**TURBOMECA****Bundstrand Power Systems / TURBOMECA
APS 3000 APU
COORDINATION MEMO**MEMO n° TS 332-0534DATE : October 25, 1991

**TO : R.A. WHITE/T. VEALE FROM: G. HARDY
A. DUCROCO
SUBJECT : LOAD COMPRESSOR FLOW
MEASUREMENTS**REFERENCE : TS 332-0428The following referenced information is ☒ (or is not ☐)
considered "PROPRIETARY" by the originator☐ REQUEST
☐ INFORMATION
☒ REPLY TO : ST 0539**REMAND****PTX 1065**

MEMO n° ST 0539DATE: OCT 1, 1991REPLY BY: OCT 18, 1991TO: G HARDY FROM: P.J. SUMMESUBJECT: LOAD COMPRESSOR FLOW
MEASUREMENT

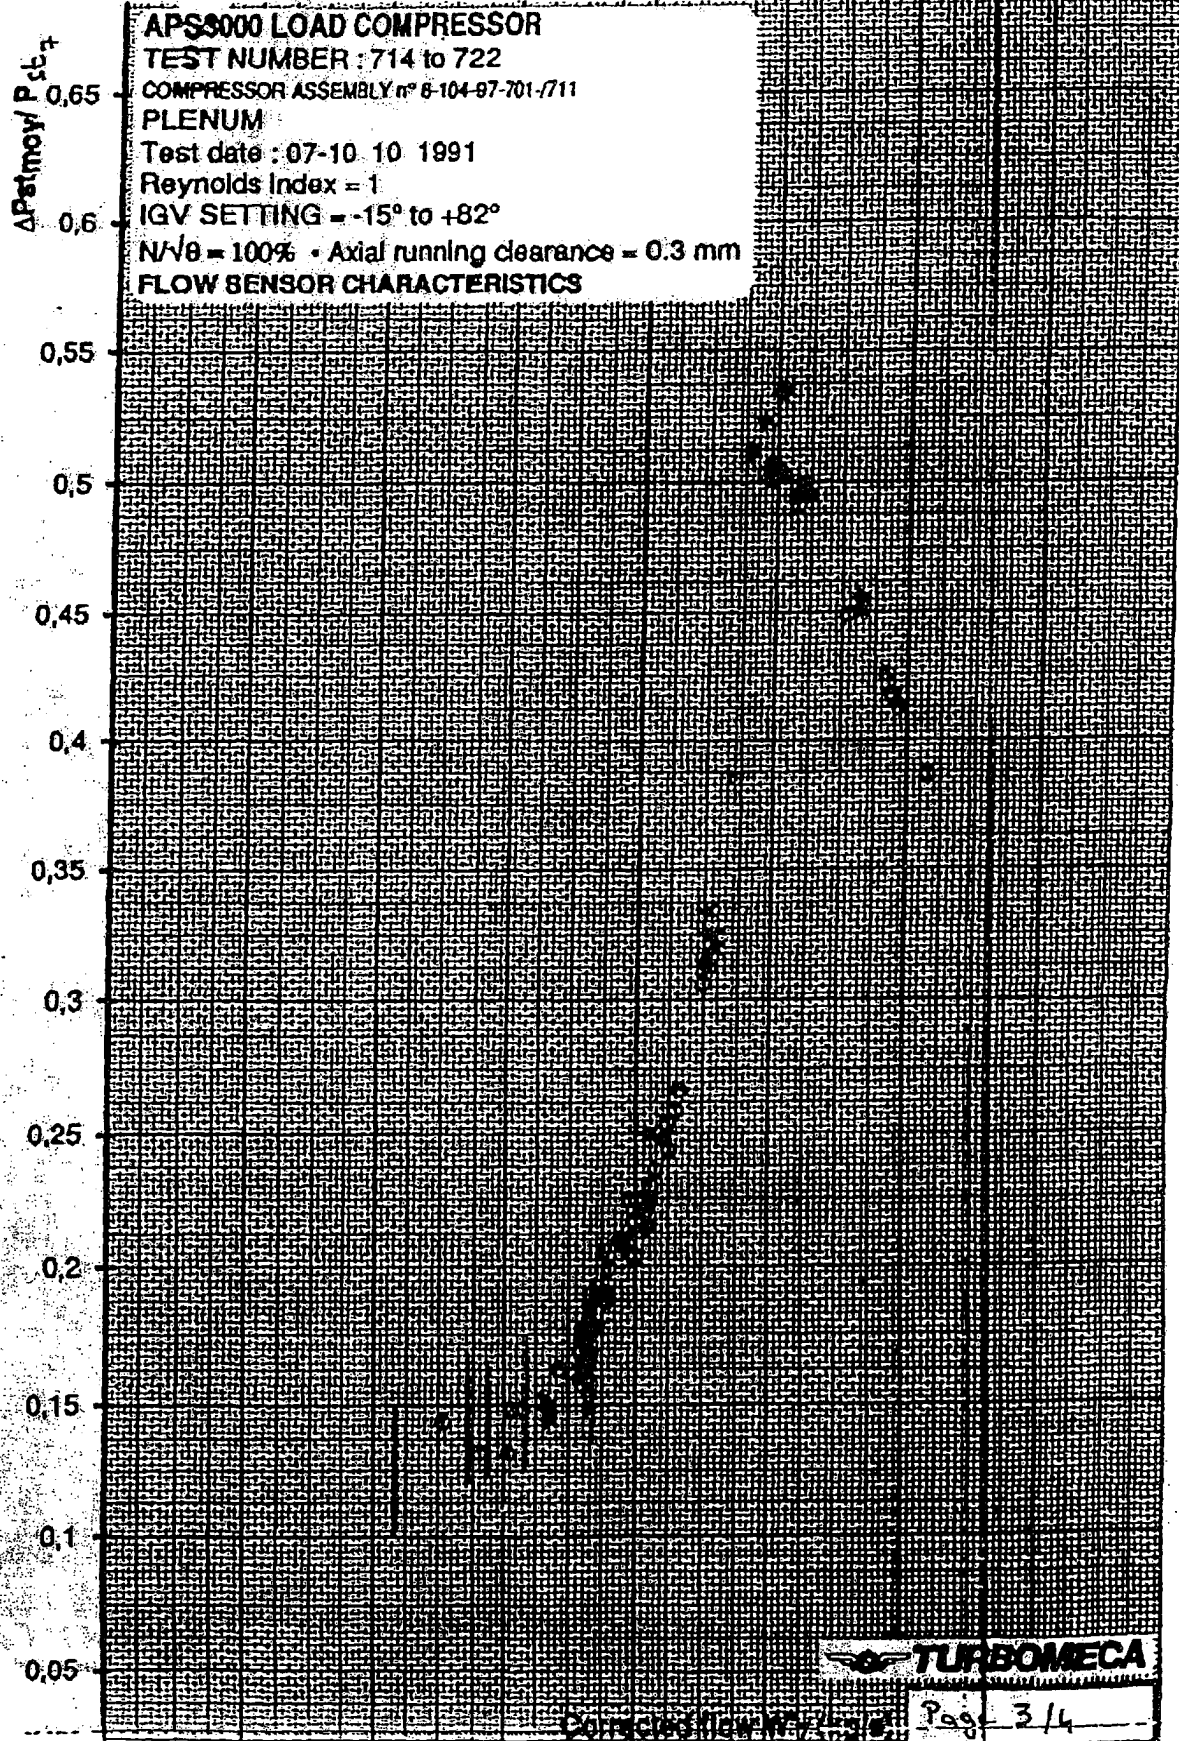
3. Airflow sensor characteristics (compressor rig test with plenum and for various IGV angles (-15° to +82°) are given p. 3/4 [$\Delta P/P = (P_{st7} - P_{st})/P_{st7}$ vs. W₇] and page 4/4 [$\Delta P/P = (P_{t7} - P_s)/P_{t7}$ vs. W₇] for the averaged static pressure (measured with 3 pressure taps located as on the engine. At $\Delta P/P \sim 0.20$, the scattering δW_7 is about 6.9 % and at $\Delta P/P = 0.25$ $\delta W_7 = 4.7$ %. This scattering should be lower with a 19 taps averaged static pressure, as planned on engine. All the measurements taken into account were done with a constant axial running clearance because axial clearance seems to have an effect on the relation $\Delta P/P = f(W_7)$.

If we compare these curves with DI engine measurements (only 1 pressure tap, with correction due to bigger axial clearance), we can see that points between $\Delta P/P = 0.15$ and 0.4 are inside the scattered rig points, but the slope is a little bit higher.

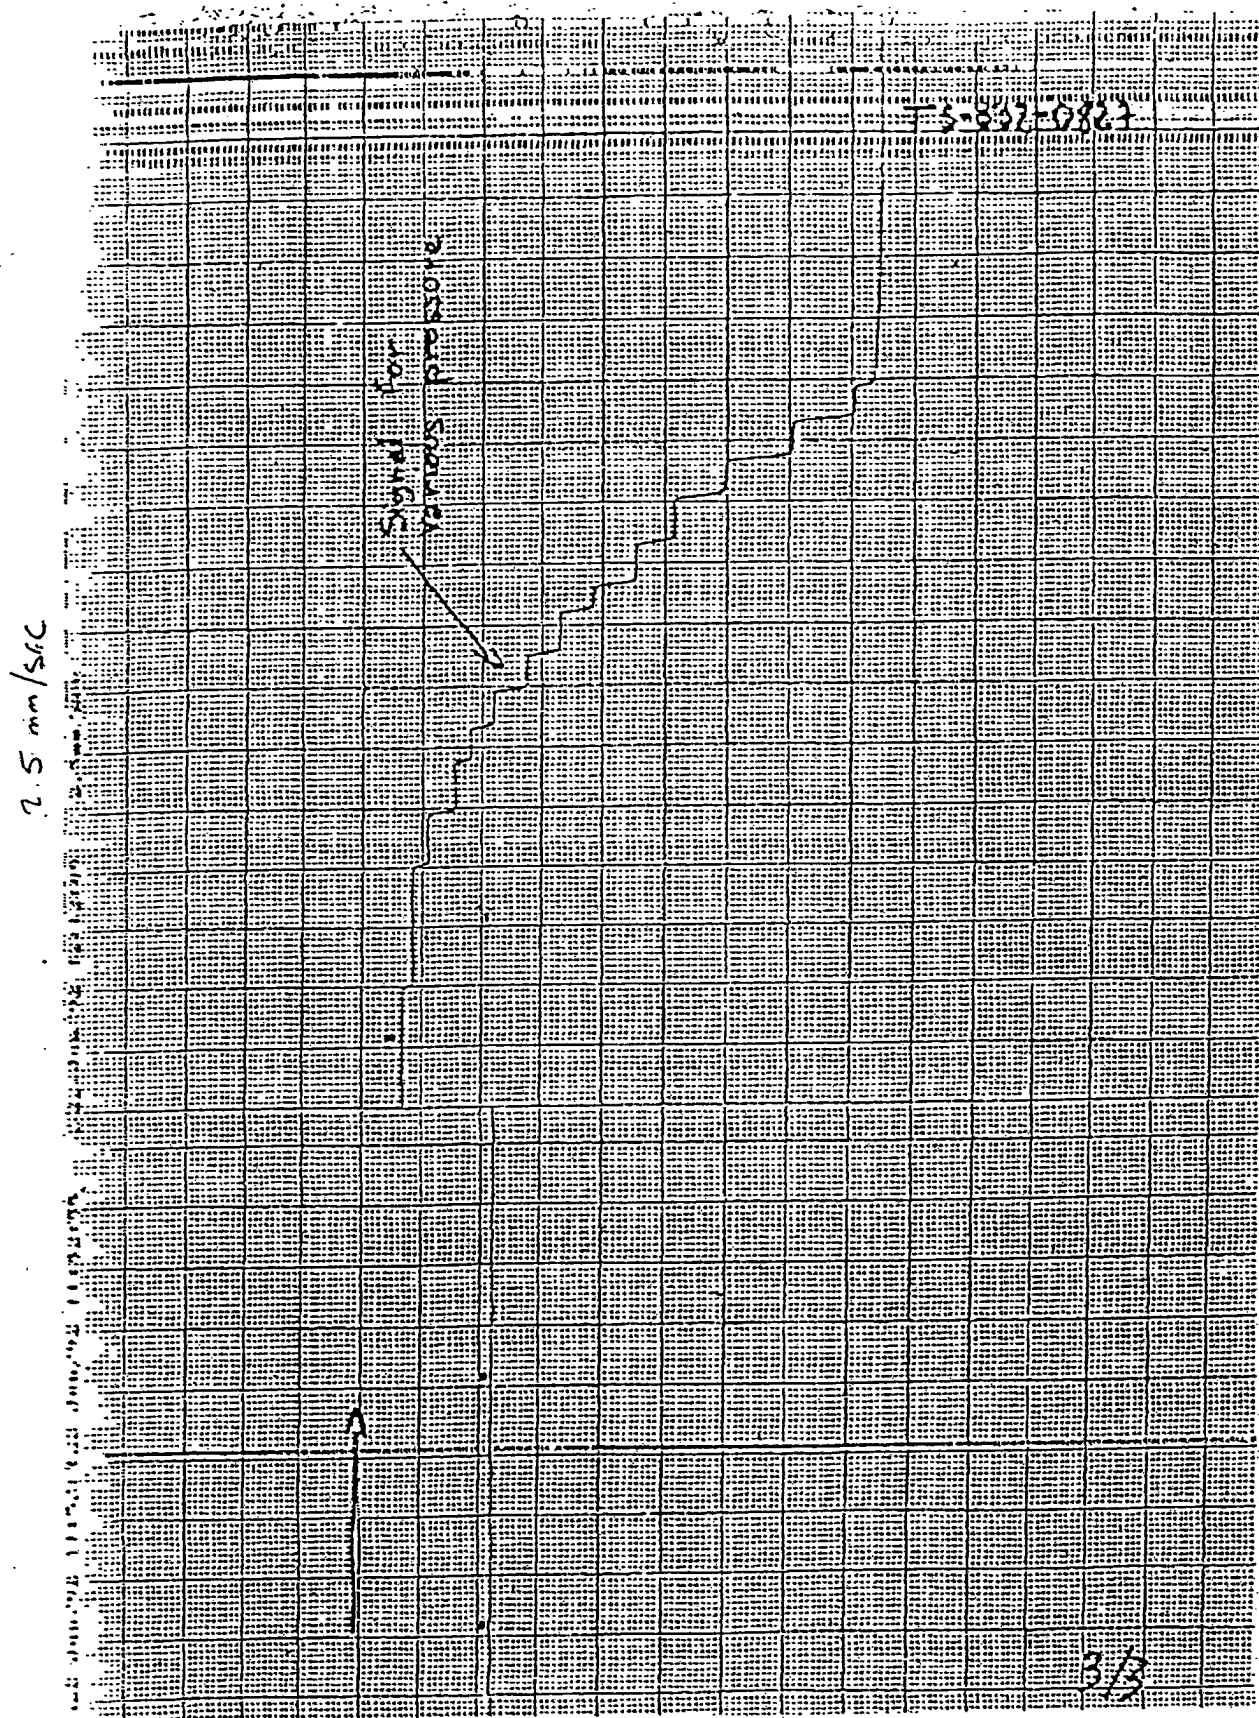
I apologize for the delay in my answer. In fact that parameter was never measured vs. time. So we have conduct a test on a GTEP 331-350 L/c module yesterday (no module where available before).
The traces attached give the value of the static pressure in the diffuser (average value of 19 holes).

As you can see the traces are absolutely flat, no noise is recorded. The signal measured is rough, without any filtering.

FIGURE 4.

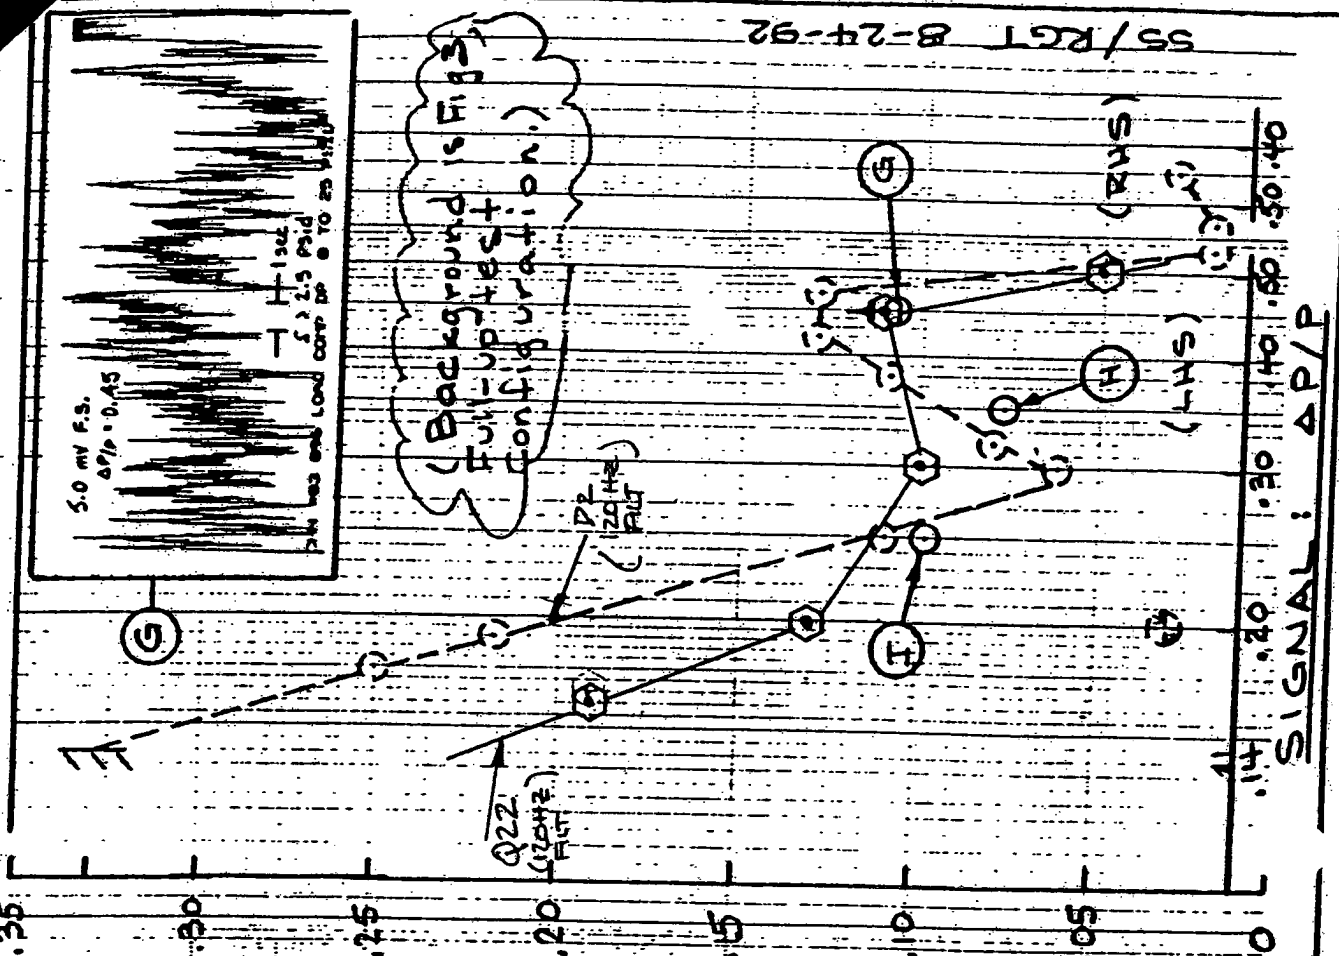
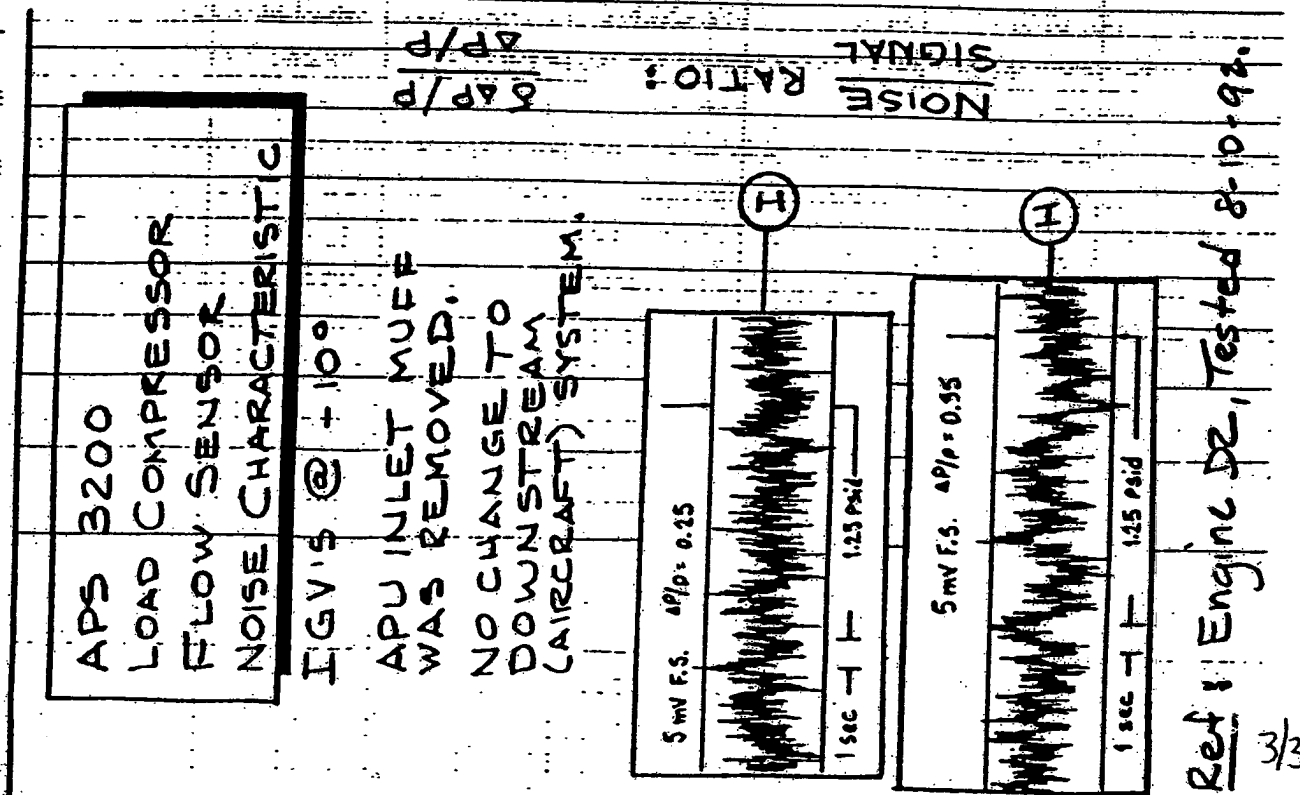
SPS HAS RECENTLY TESTED Q22 IN THE DA TAILCONE. ATTACHED PLEASE FIND A COMPARISON PLOT SHOWING THE DIFFERENCES BETWEEN D2 (1 HOLE DIFFUSER) AND Q22 (19 HOLE DIFFUSER) BOTH IN THE TAILCONE. THIS REPRESENTS A DIRECT "BACK TO BACK" COMPARISON. AS YOU CAN SEE THERE IS A REDUCTION IN THE SIGNAL TO NOISE RATIO HOWEVER THE LEVELS OF NOISE ON THE DELTA PRESSURE SIGNAL WILL STILL PREVENT ACCEPTABLE CLOSED LOOP CONTROL OF THE LOAD COMPRESSOR.
